MAMARONECK BEACH AND YACHT CLUB
555 SOUTH BARRY AVENUE
VILLAGE OF MAMARONECK, NEW YORK

FINAL SUPPLEMENTAL ENVIRONMENTAL IMPACT STATEMENT
PROPOSED SANITARY SEWER SYSTEM UPGRADE

July 2017

SCHEMATIC PIPELINE BRIDGE (PLAN)

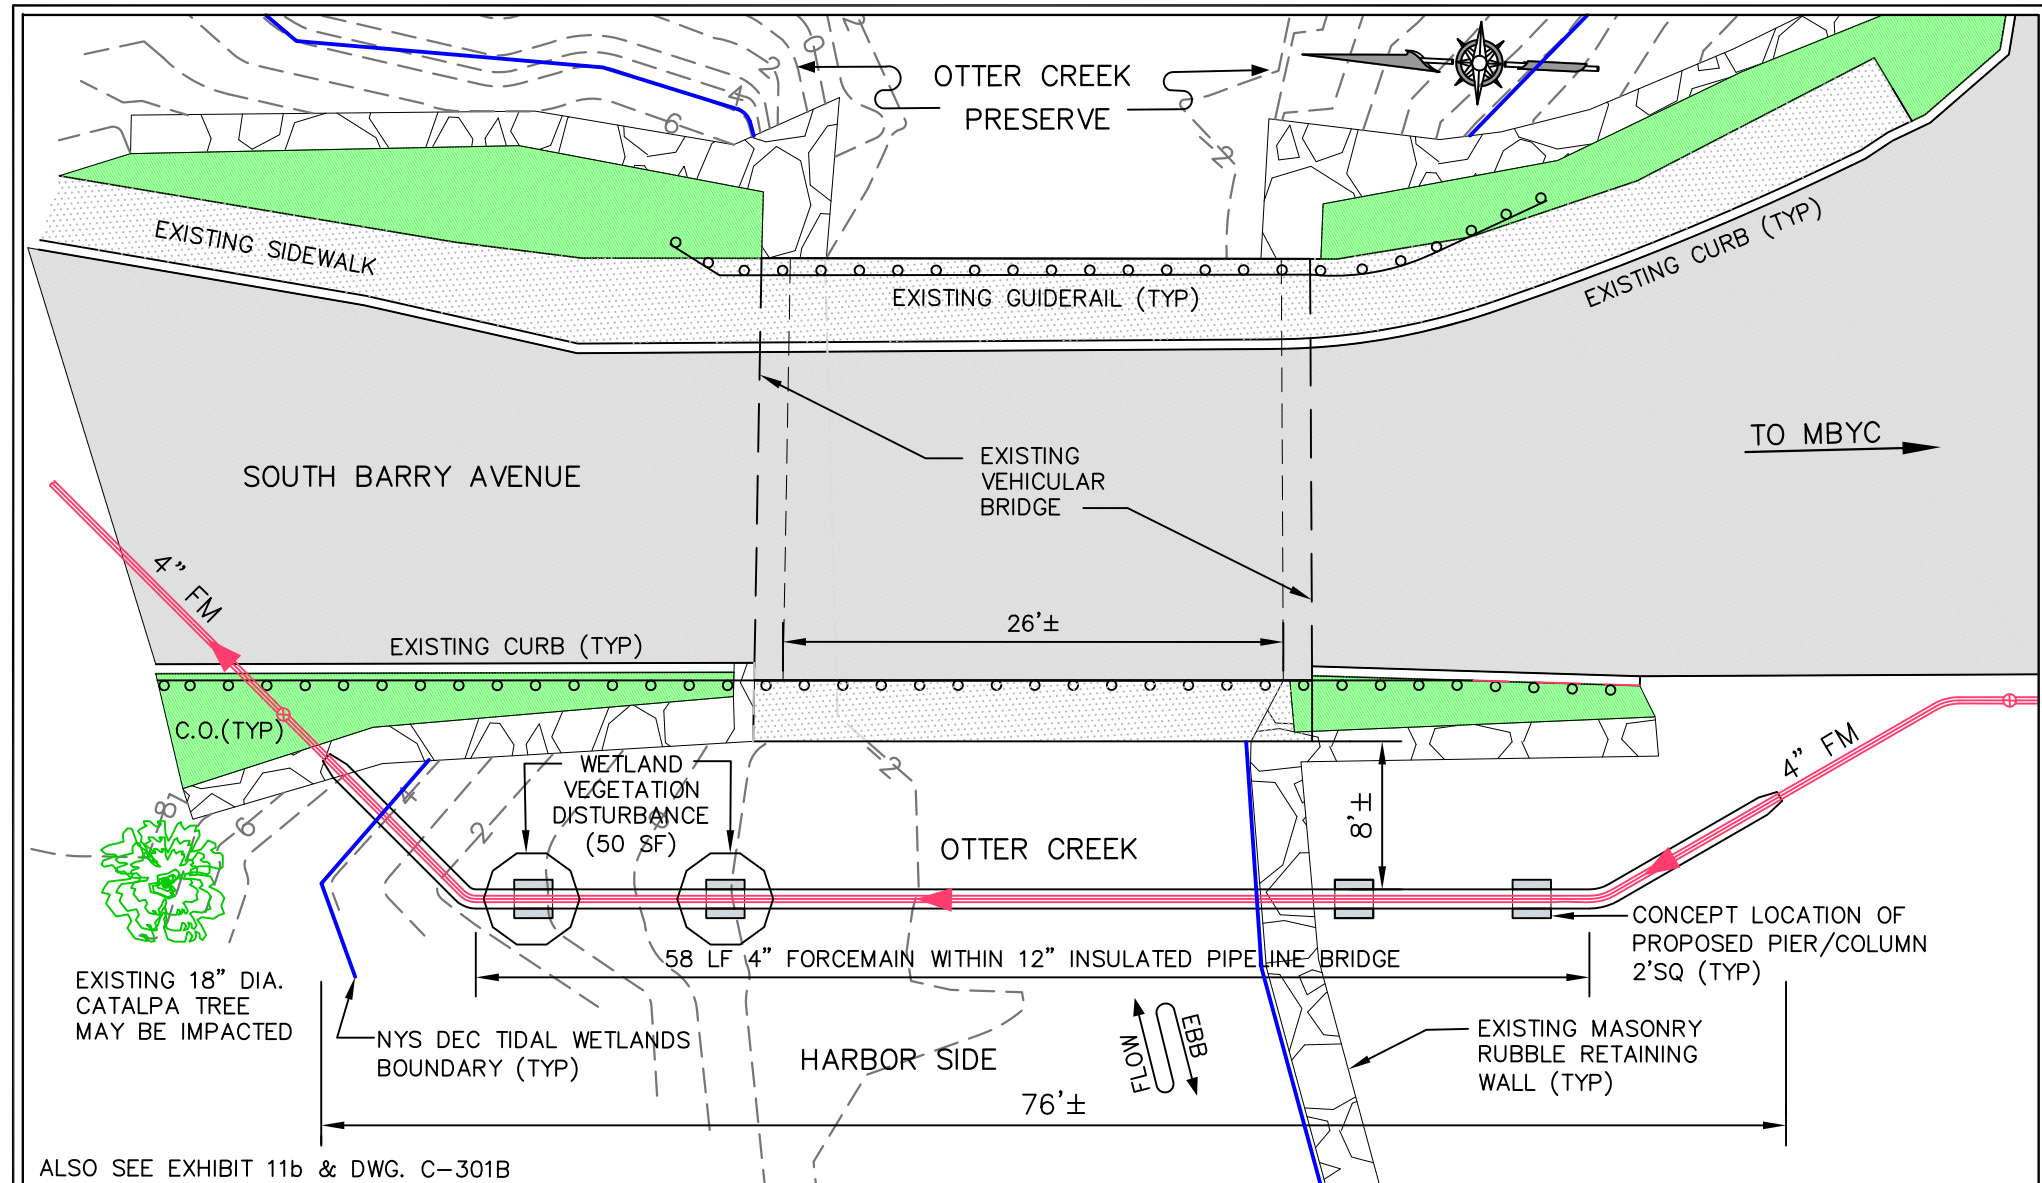
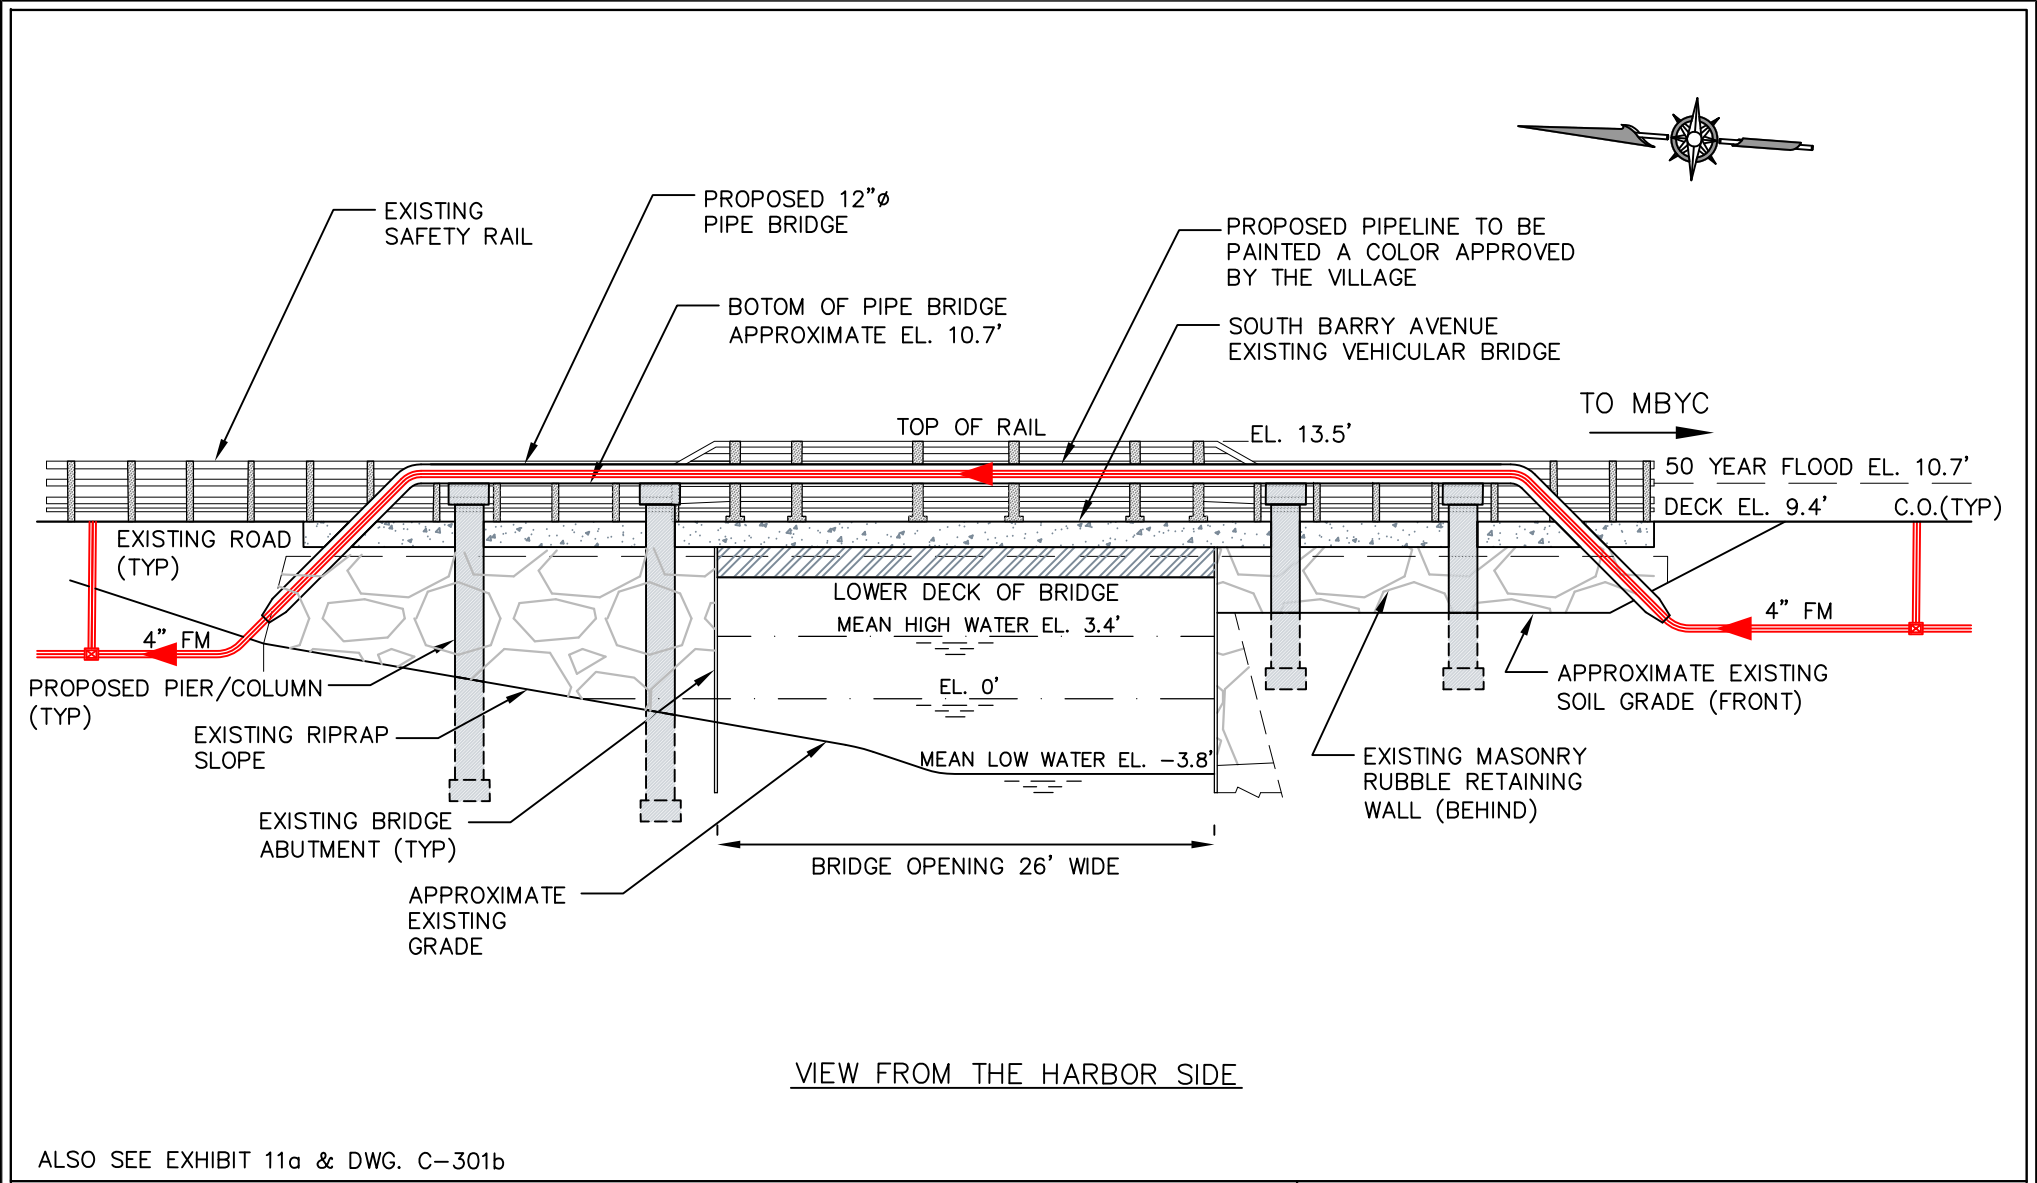
Your attention is directed to the *previous DSEIS Exhibit 8* (shown above) and current DSEIS Exhibits 8b and 8a, which clearly show, probably better than we can describe, why being over the west side of the bridge from a visual, environmental and practical approach makes more sense. *Daniel Natchez, President Daniel S. Natchez and Associates, Inc; Shore Acres Property Owners Association, Letter, May 11, 2016, Pg. 9, para. 1 - 8*

In addition, the southwestern terminus of the proposed pipeline bridge appears to be located very close to a detached garage, as well as what appears to be a storm drain. The detached garage is depicted on Exhibit 7 but not on Exhibit 8a. The storm drain appears on Google Street View (August 2013). Potential impacts to these structures should be addressed. *BFJ Planning, Memorandum, June 13, 2016, Pg. 6, para. 2*

NYS DEC Tidal Wetlands Map

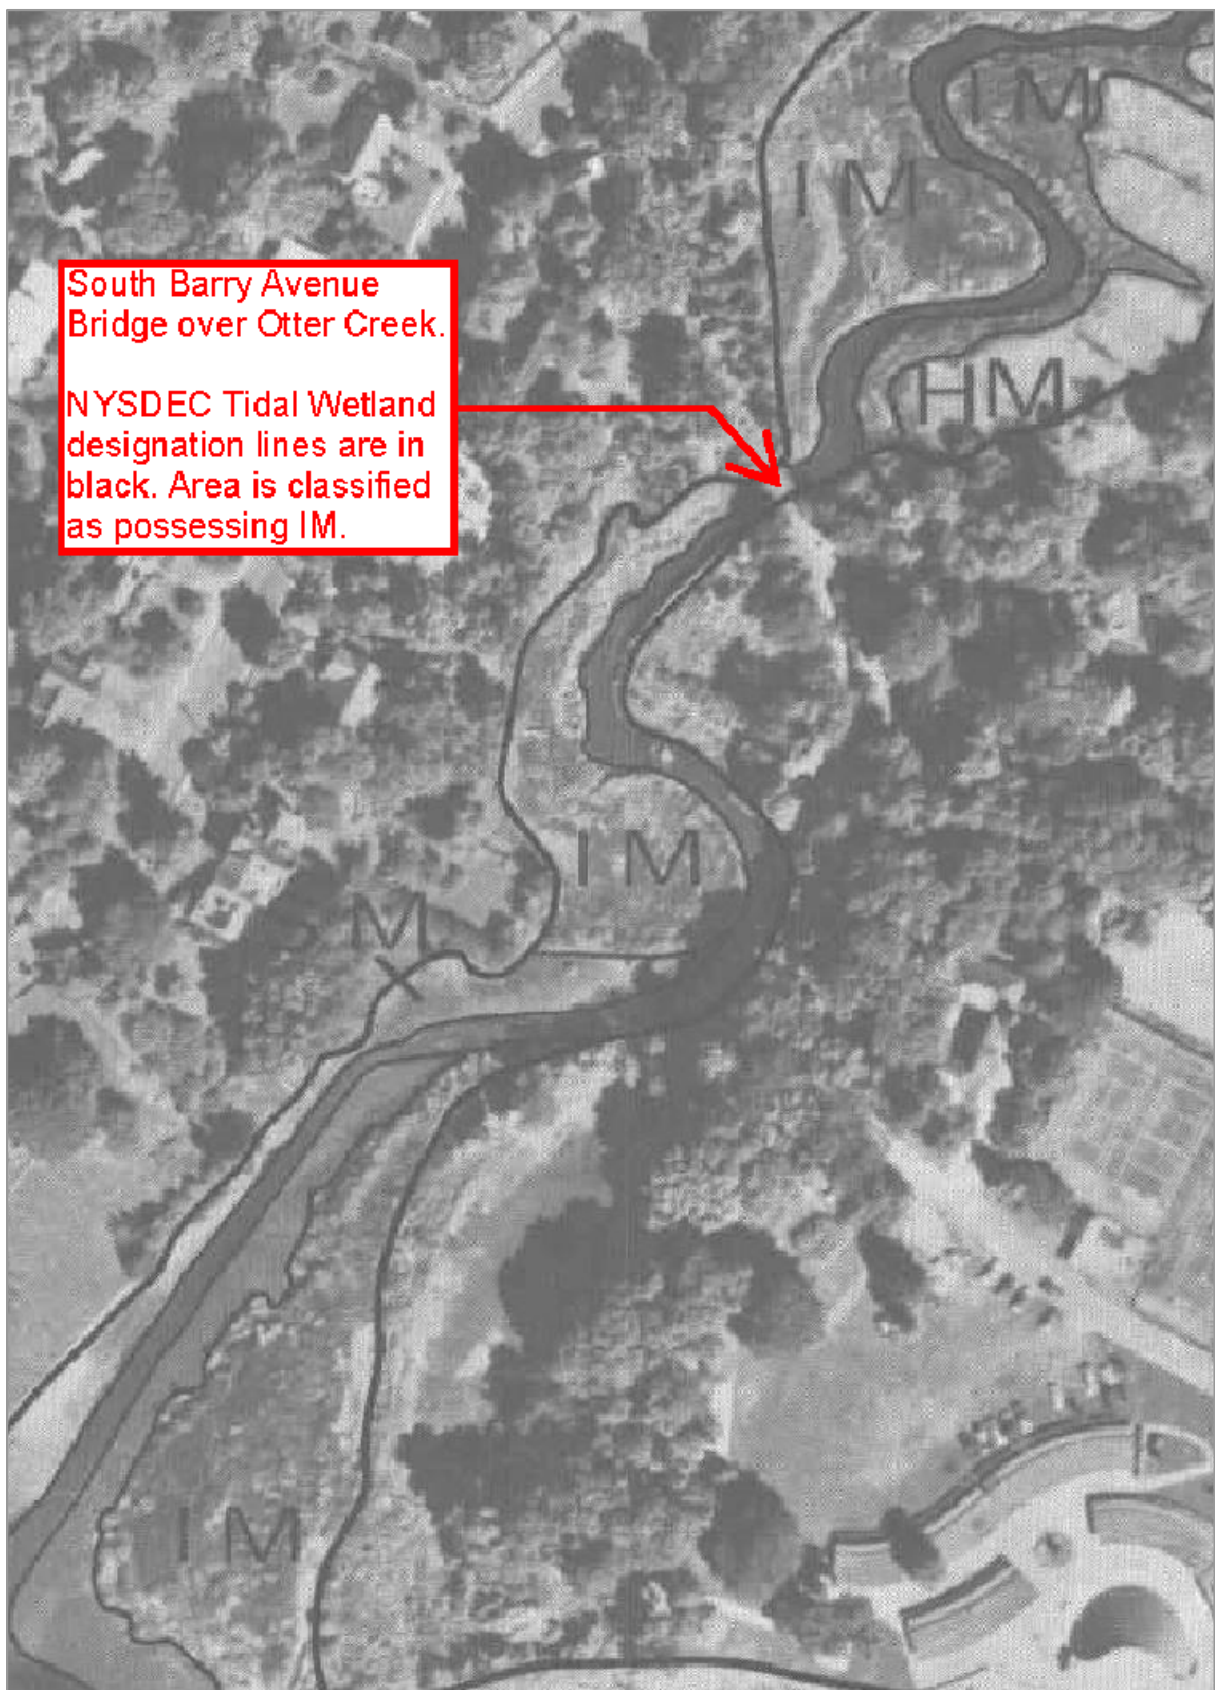
No wetland delineation has been conducted by the Applicant, and instead the DSEIS relies on a 1974 NYSDEC Tidal Wetlands Map (Exhibit 10) and “site inspections by members of the project team” (see p. 28). We question whether this data is sufficient to fully understand the boundaries of the tidal wetlands along Otter Creek or to support the DSEIS’s assertion that no vegetated tidal wetlands will be “adversely impacted by the proposed force main options currently under consideration” (p. 28). *BFJ Planning, Memorandum, June 13, 2016, Pg. 2, para. 3*
